Version 3

Rattling from the Front of the Vehicle

Supersedes 20-036, dated June 3, 2021, to revise the information highlighted in yellow

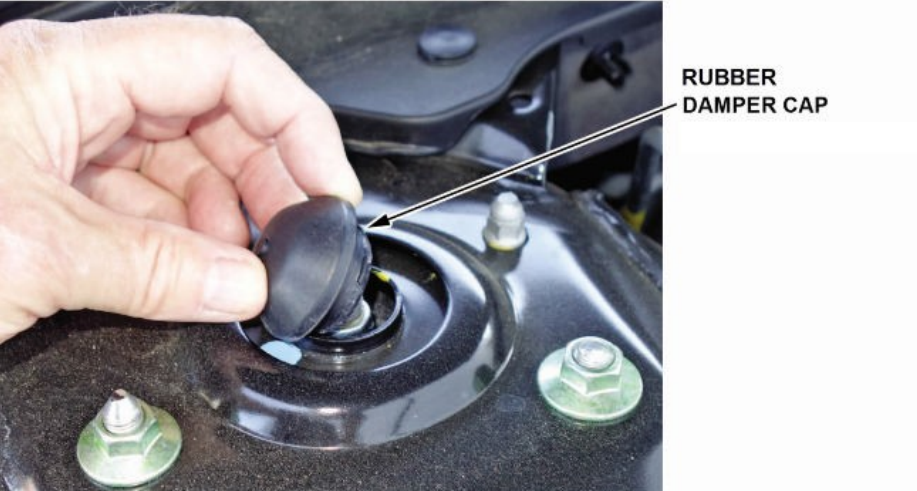
The rubber damper cap(s) are faulty.

Remove the rubber damper caps, then test-drive the vehicle.

Replace the rubber damper caps.

- If you no longer hear a rattling from the front of the vehicle with the caps removed, go to REPAIR PROCEDURE.
- If you still hear a rattling from the front of the vehicle with the caps removed, this bulletin does not apply. Continue with normal system troubleshooting.

Install the new rubber damper caps on both sides.
